Name: Mesa National Bank – Site Plan Review/Minor Change- Drive Thru-SW Corner 12th/F Rd

GENERAL PROJECT REPORT (PROJECT SUMMARY)
MESA NATIONAL BANK - PATTERSON BRANCH
1199 Patterson Road
Grand Junction, Colorado 81501

REVIEW COMMENTS

TITLE HEADING: Site Plan Review & Minor Change -
Drive-thru for Bank - Village Faire
Shopping Center

2.A REVISED ENLARGED PARTIAL SITE PLAN
A1 1/8" = 1'-0"

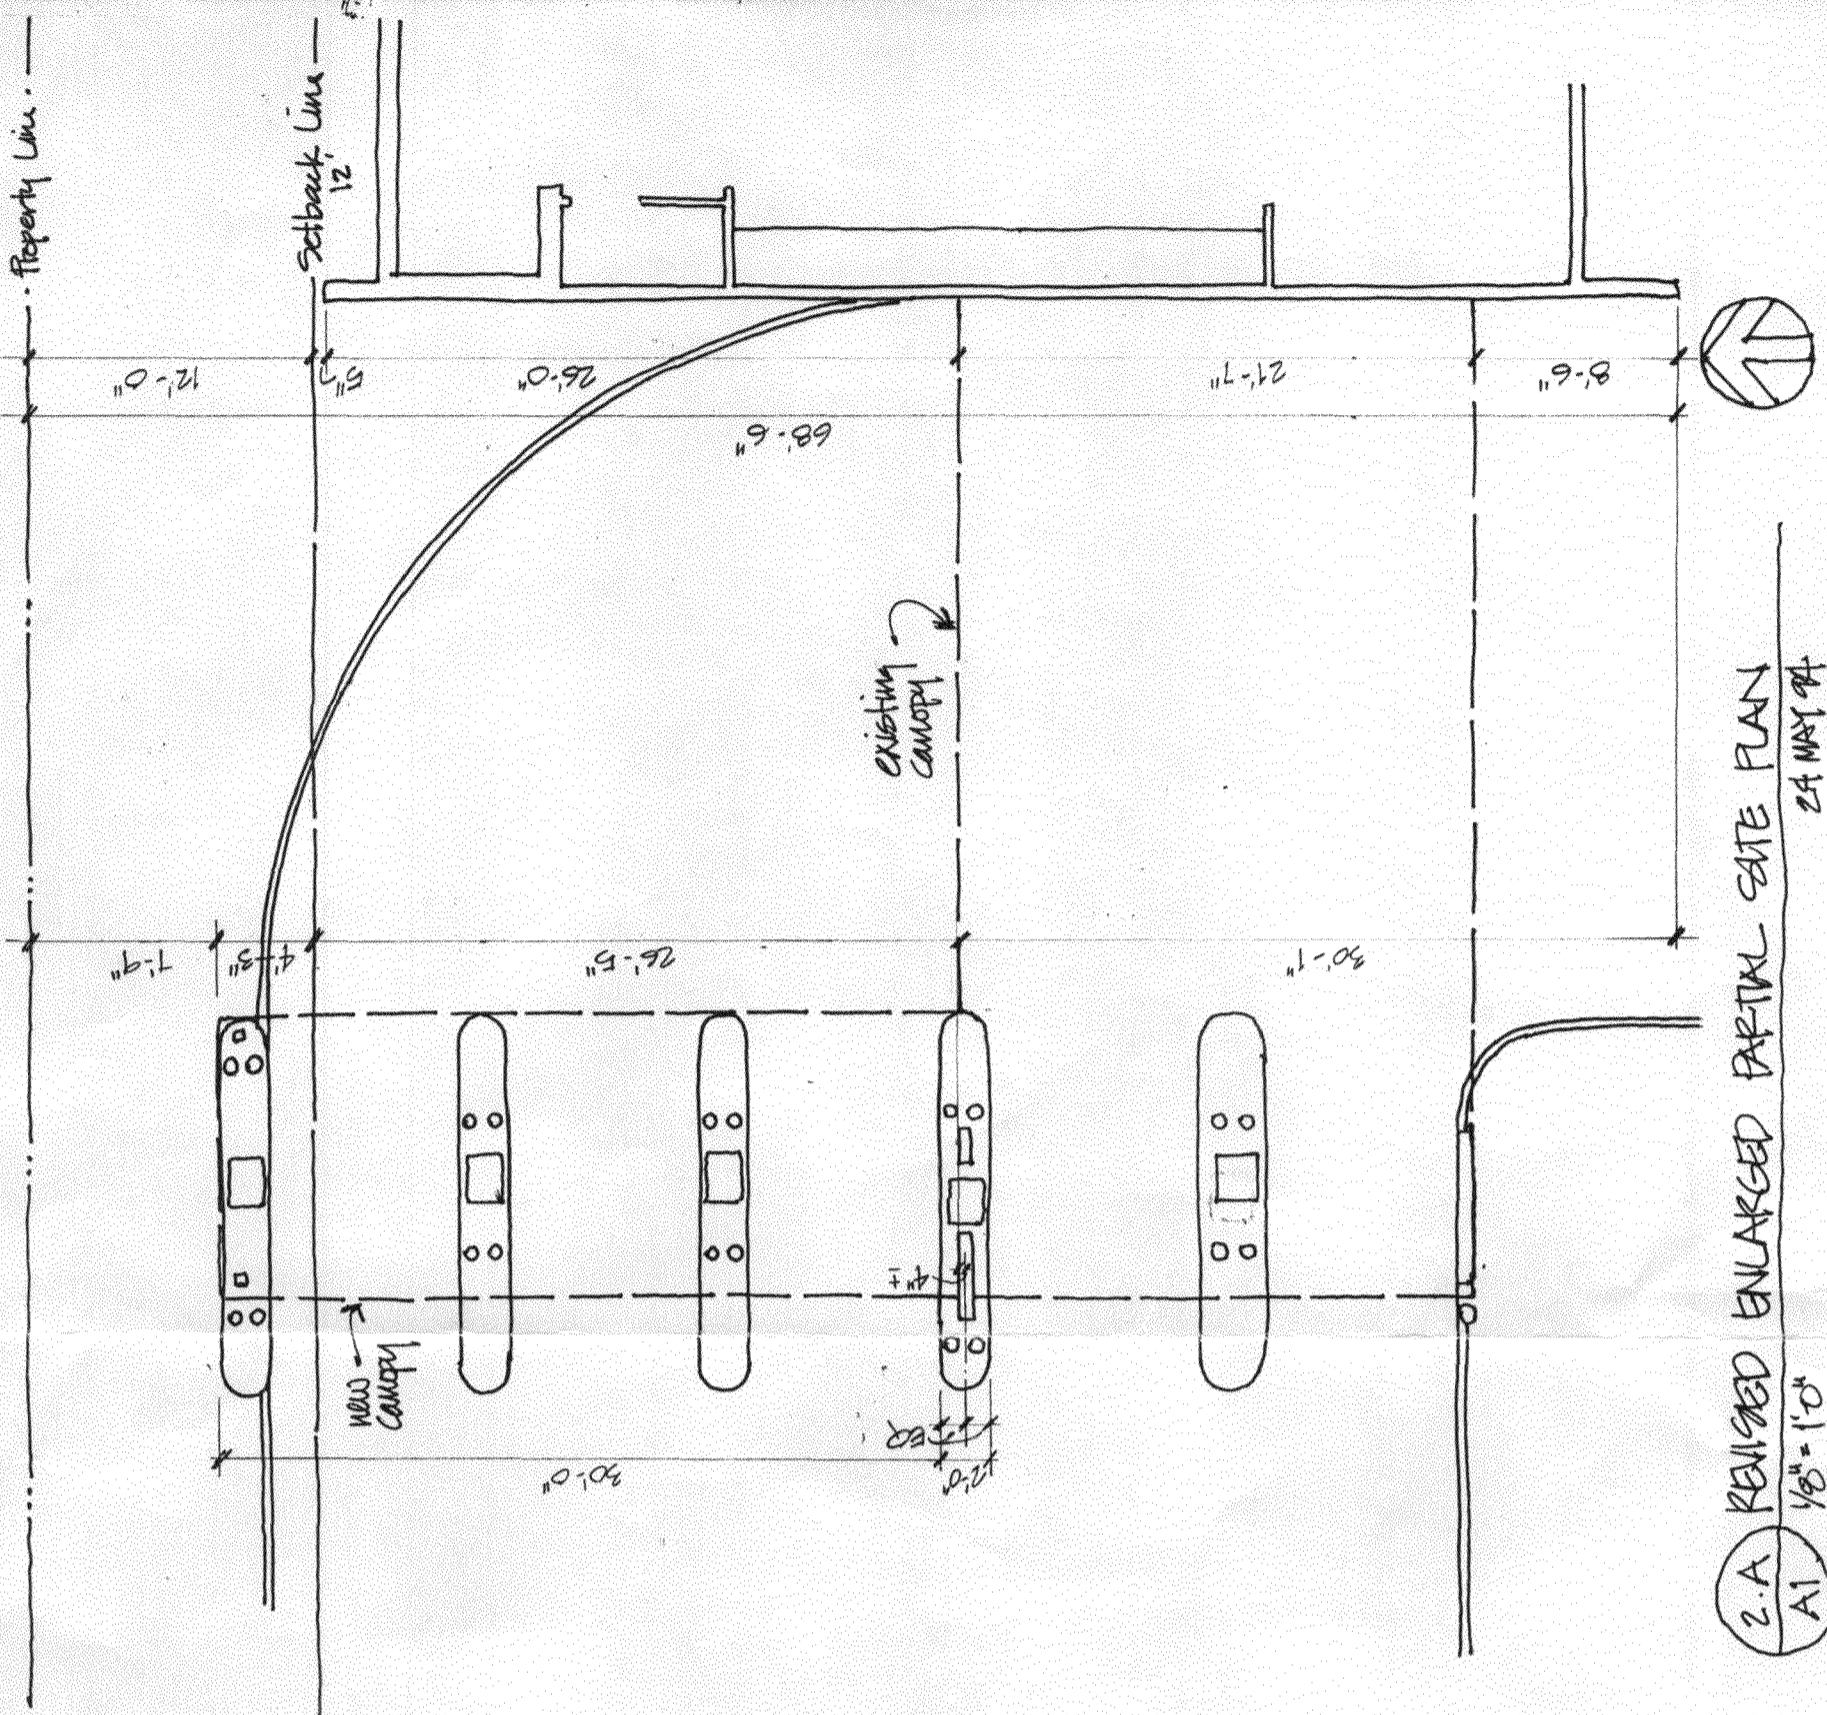
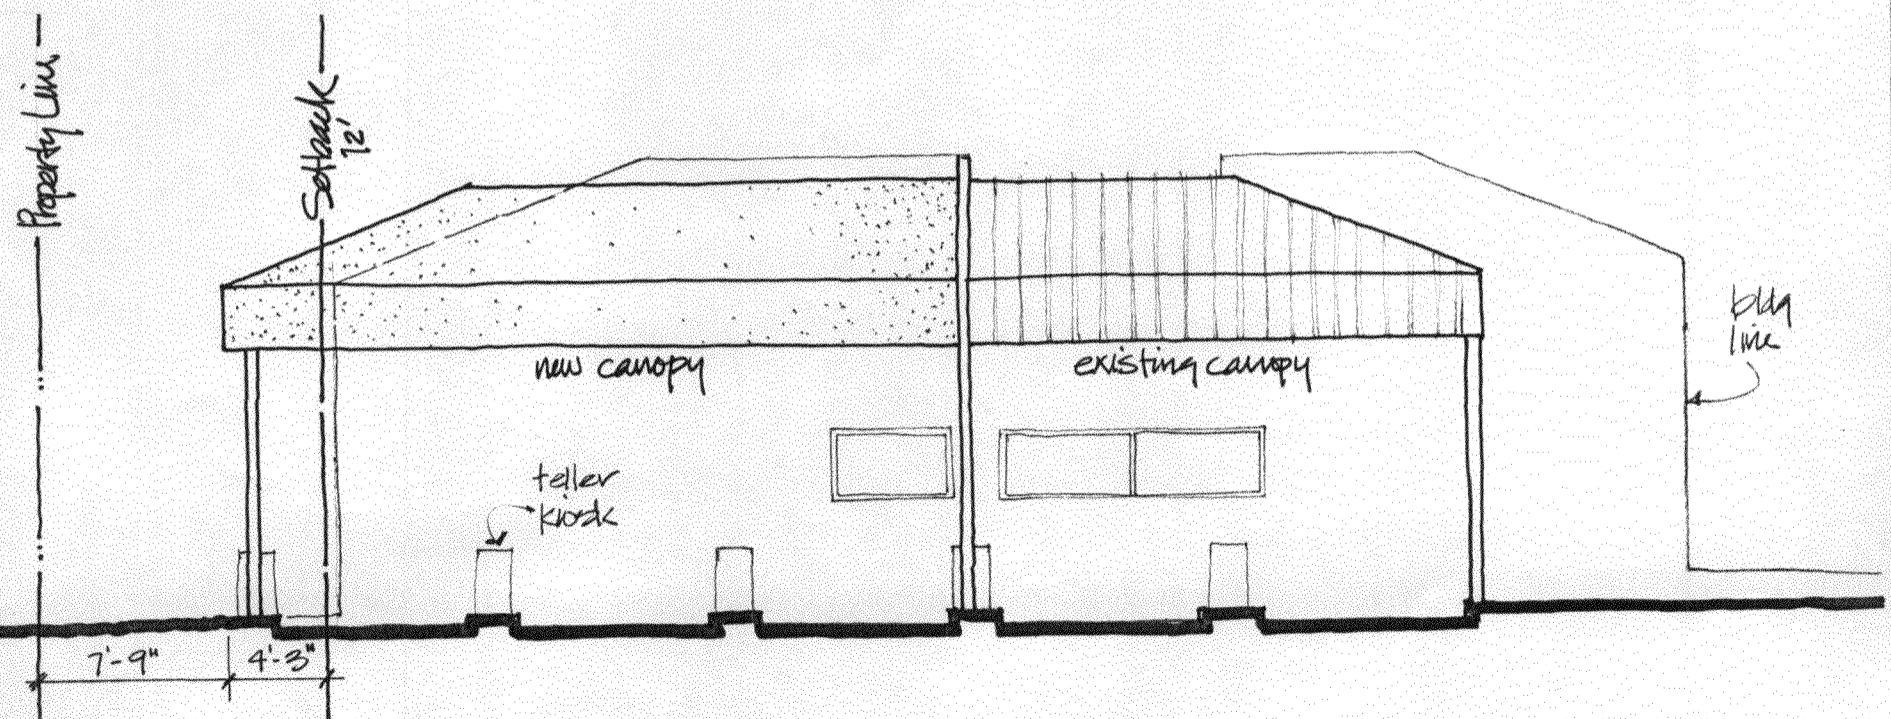
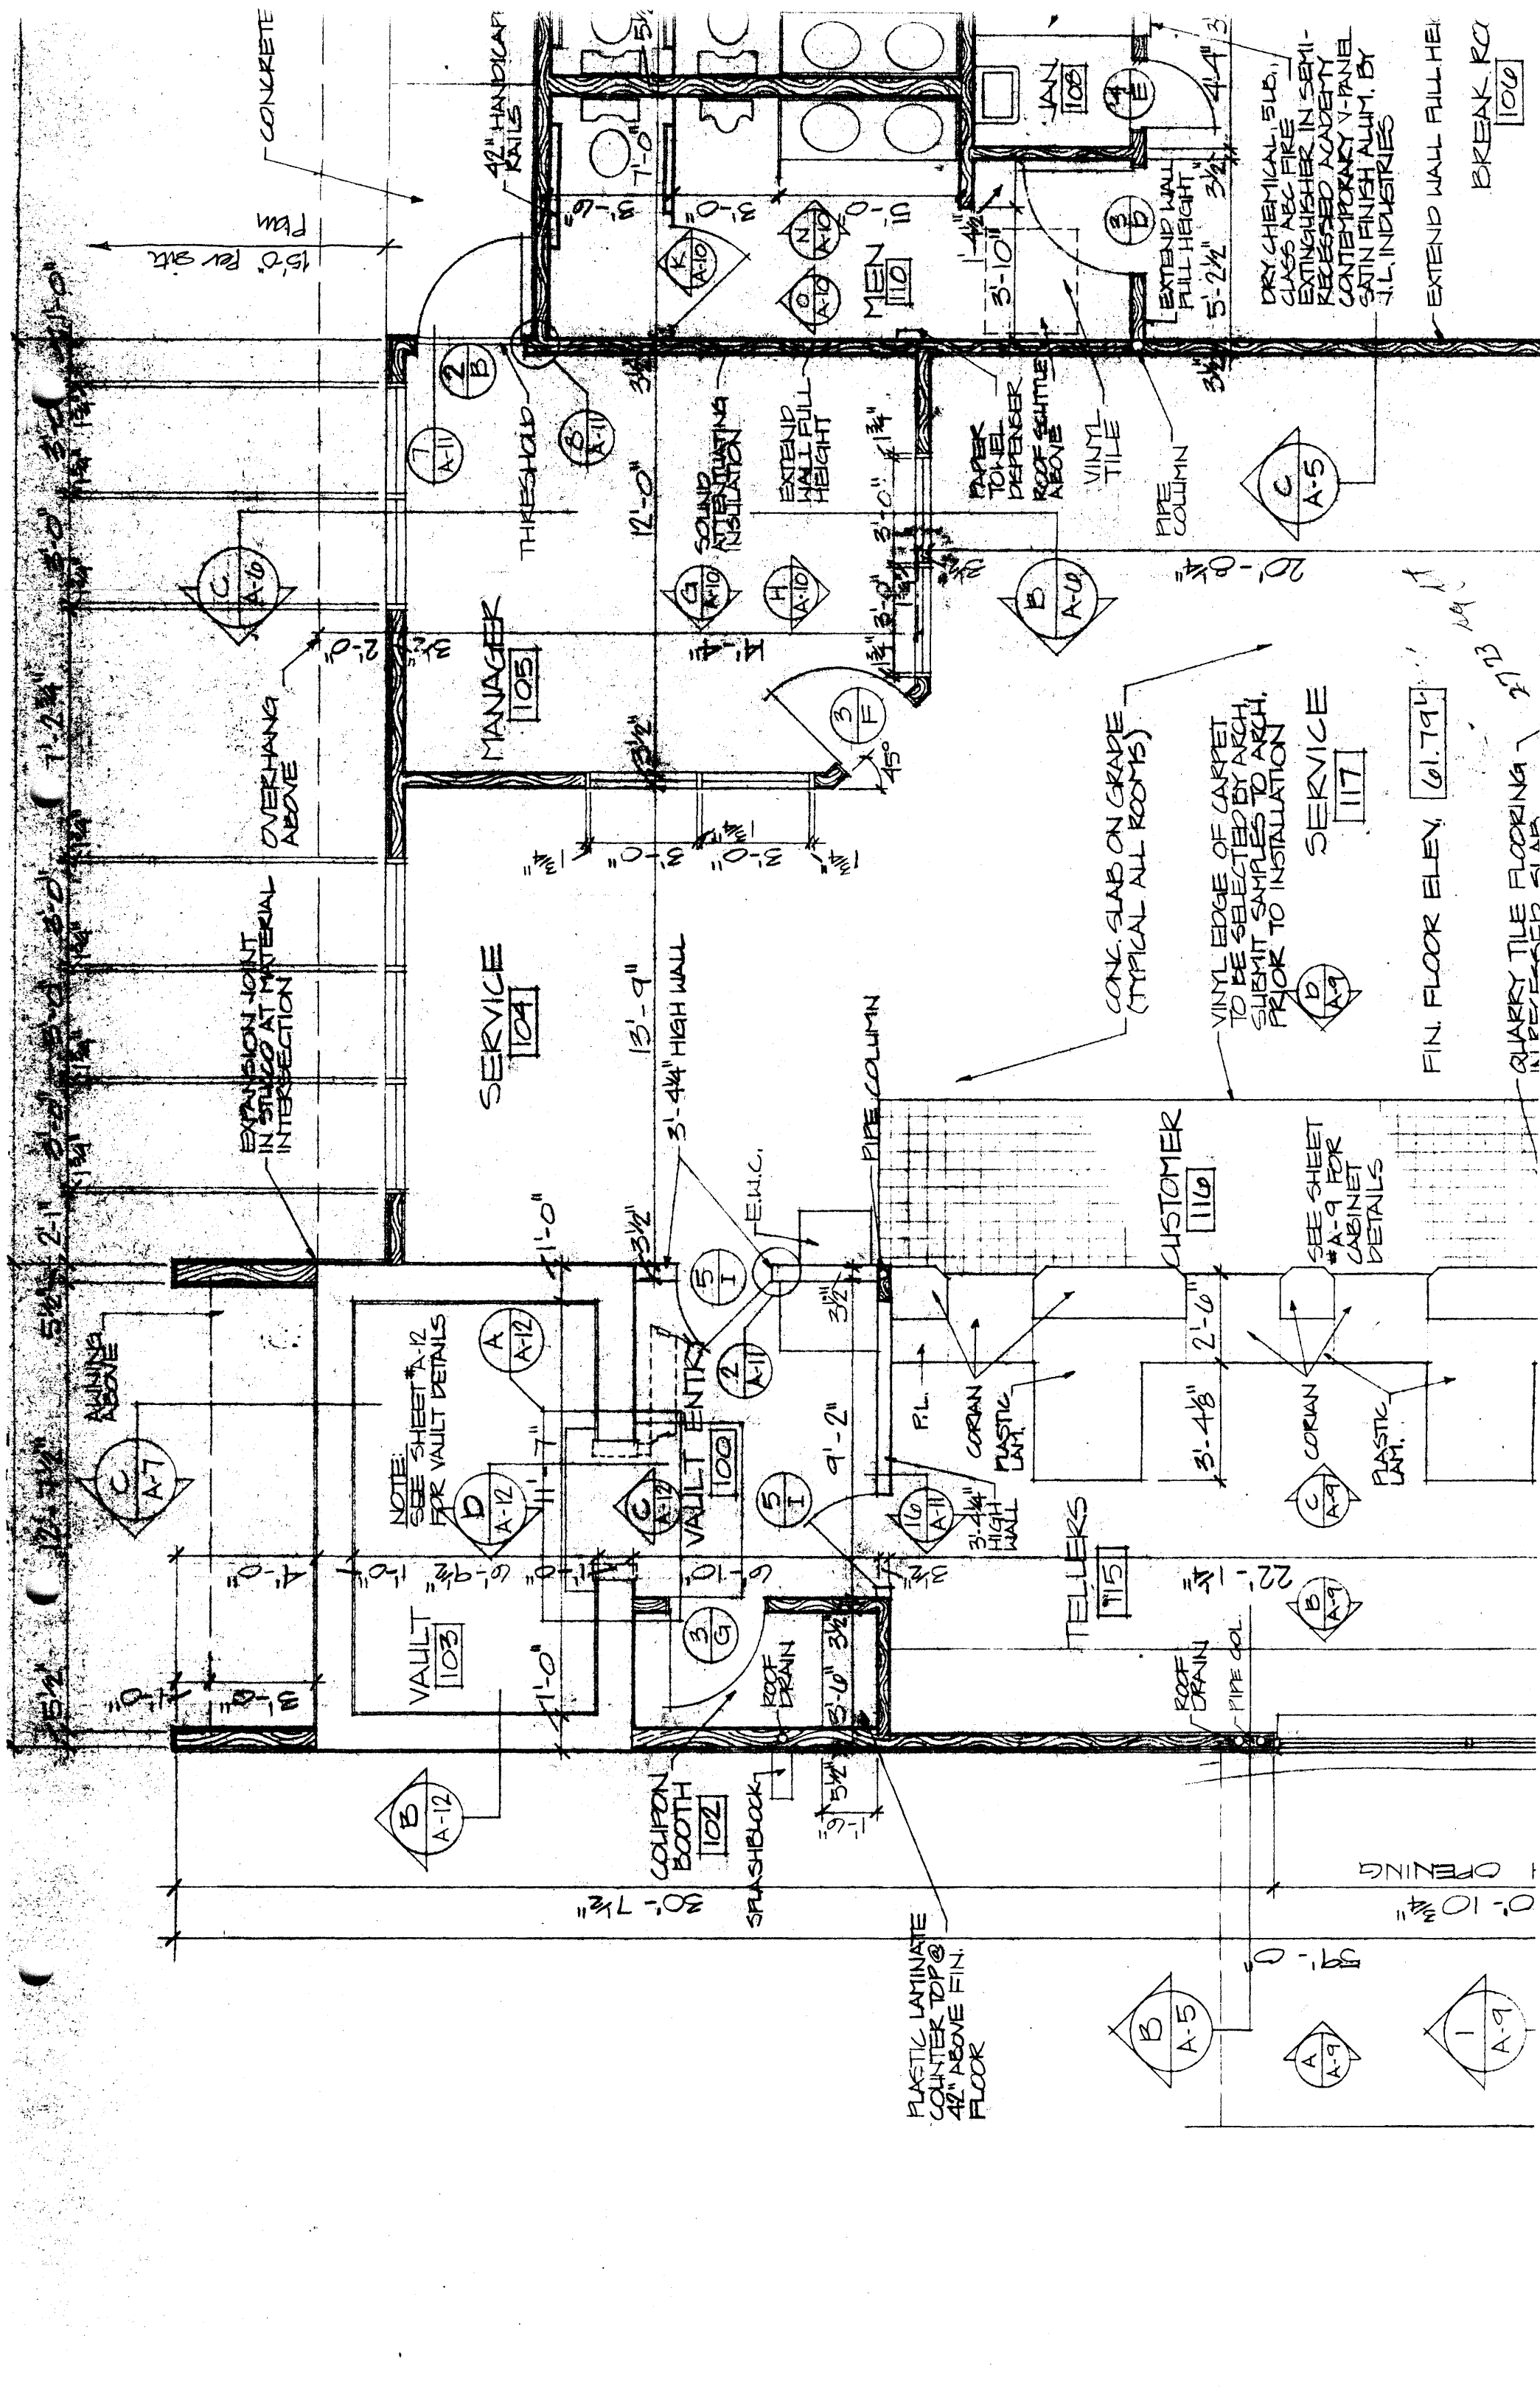
Here is the latest and greatest for the location of the northernmost drive-up kiosk island for the new drive-up addition area at MNB-Patterson. As you can see on the hand sketched Revision sheet which includes an enlarged partial site plan and west elevation, the edge of the 2'-0" wide island encroaches approximately 4'-3" past the setback line. If the bank elects to place a 3'-0" island in the event that an ATM machine would be installed in the future, then the island would encroach 5'-3" into the setback line.

Please take a look at the elevation, and notice that the canopy should not visually dominate the area since it is supported by slender tube steel columns, and therefore the sight line is not greatly obstructed. If an ATM is placed in the future, then the visual characteristics would change and be dependent upon the manufacturer's weatherproof "shell" used to surround the equipment. At this time, MNB has decided not to place an ATM on the island.

City of Grand Junction Planning and Engineering staff has reviewed the most recent site plan and elevation (dated 24 May 1994) for the expansion of the Mesa National Bank drive-thru at 12th & Patterson. We have no concerns with the revisions--the encroachment of the northern-most island and the new canopy into the Patterson Road setback, as established by the bank building itself, will not adversely impact development on this or adjacent sites. Thus, a Planning Clearance for a Building Permit will be issued by the Community Development Department as soon as your client is ready to proceed on the project.
